hess-2019-136

Determinants of thermal regime influence of small dams

Status: Final Response (HESS Discussions) to referee#2

Figure 7. PCA analysis. Correlation circle with temperature as active variables

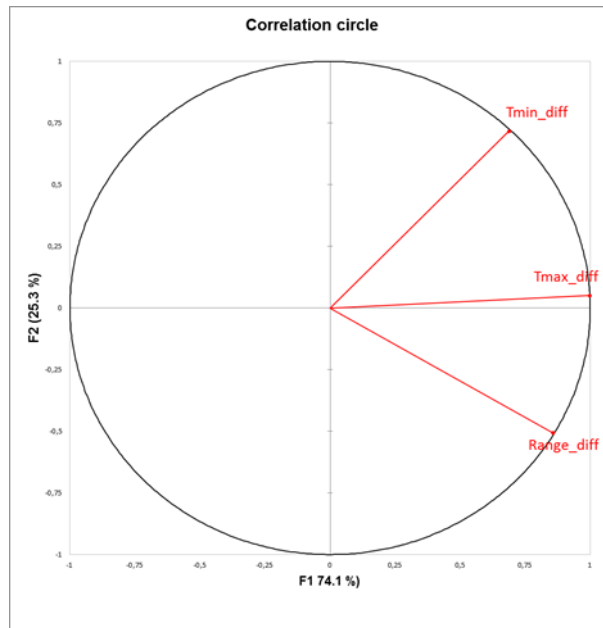
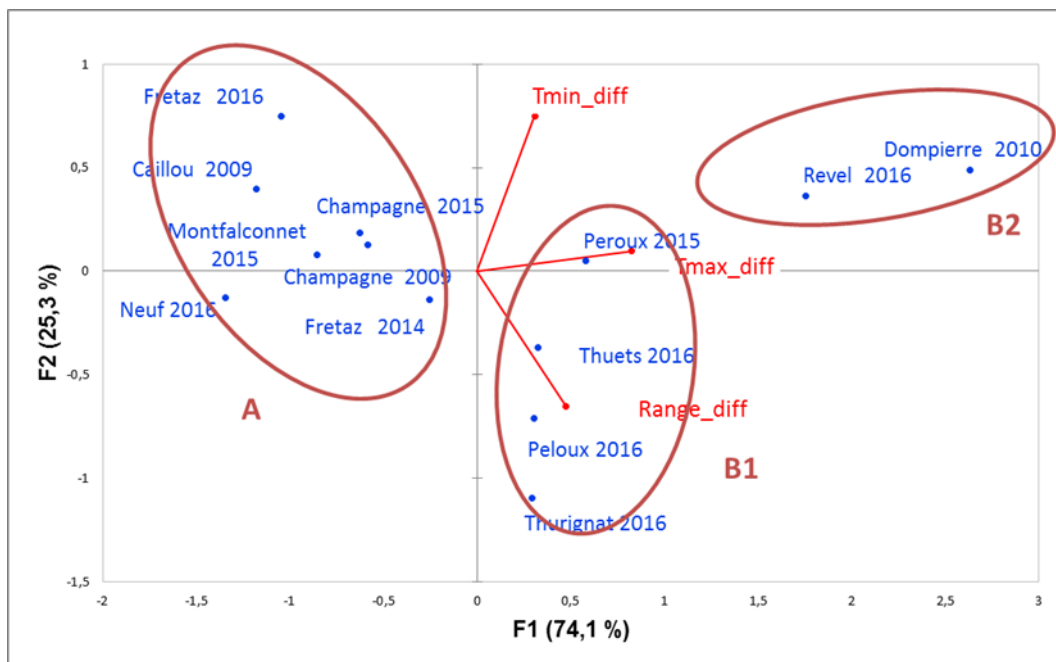
"Section 2.5: Please elaborate further on how you performed your PCA. Illustrative variables are explanatory variables? "In order to identify characterization of the impacts of the different dams" – reformulate, unclear!"

The first axis of the PCA analysis (74.1% of total inertia) is correlated to all temperature daily variables (calculated as differences between downstream versus upstream), in particular to the maximum daily temperature difference (Tmax_diff). The second axis (25.3%) discriminates the daily amplitude difference (Range_diff) with the minimum temperature difference (Tmin_diff) (Fig. 7). Results of the RDA show that the water residence time and the impoundment surface explain 95.2% of the PCA structure (time series plotted on the first and second axis). The projection of the site series

on these axes shows a strong spreading along the first axis. The dams that had two different measurement years stay within the same range on this first axis (i.e., Fretaz and Champagne) (Fig. 8).

Figure 7 and 8 change to

Figure 2. Time-series of water temperature (°C) upstream (blue) and downstream (red) of the dam Fretaz, Veyle stream, respectively in years 2014 and 2016.

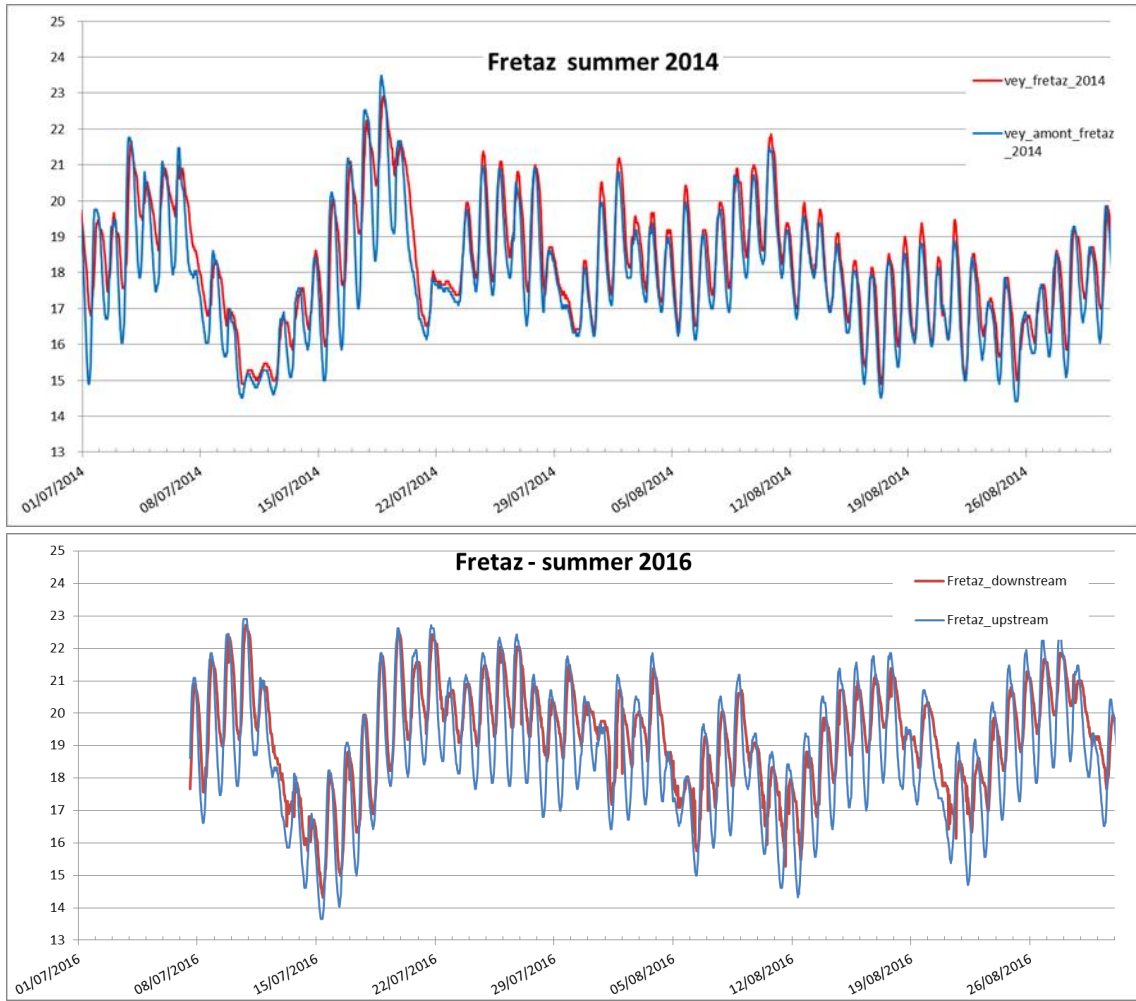
"Section 3.2/ Fig. 4: I understand that the scatter plot for Dompierre shows "type 2", so like in Figure 3. However, Neuf in Fig. 4 does not show "type 1", like in Figure 2, because there is almost no difference between minimum temperatures up- and downstream. And, why don't you simply show the same data in your timeseries plots (Fig. 2 and 3) and the scatterplot (Fig. 4) to illustrate the two types. Also, better to combine the figures and make the two types more clear by that."

Response: We follow the recommendation and propose a new set of figures

Fig. 2 Fretaz 2014 and 2016

Figure 10. Mean of the daily maximum duration with T above 22 °C , upstream and downstream each site monitored in the study. A (circles), B1 (triangles), B2 (rhombus) are the groups of sites resulting from HCA.

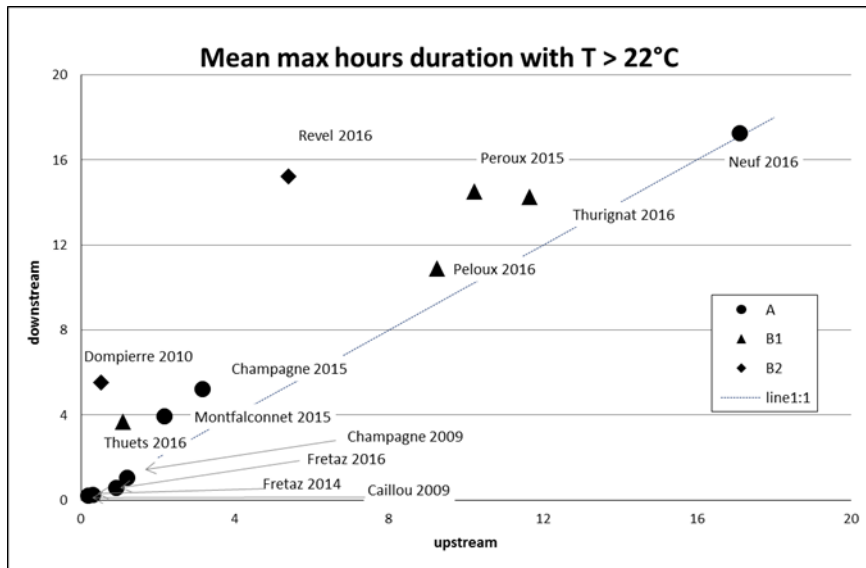
"Section 3.7: Confusing to speak of "short period of time" or "three consecutive days" – what you actually do is to look at shifts in intra-daily temperature variation."

For all sites, by studying the average daily duration with a temperature exceeding 22°C continuously, we can see (Fig. 10):

- downstream durations are always greater than or equal to that of the upstream durations, regardless of site typology,
- the largest upstream/downstream differences occur in the group B2 group,
- group A is generally not affected by an upstream/downstream increase, except for two sites which exhibit a two hour increase.

We add a new figure (Fig.10)
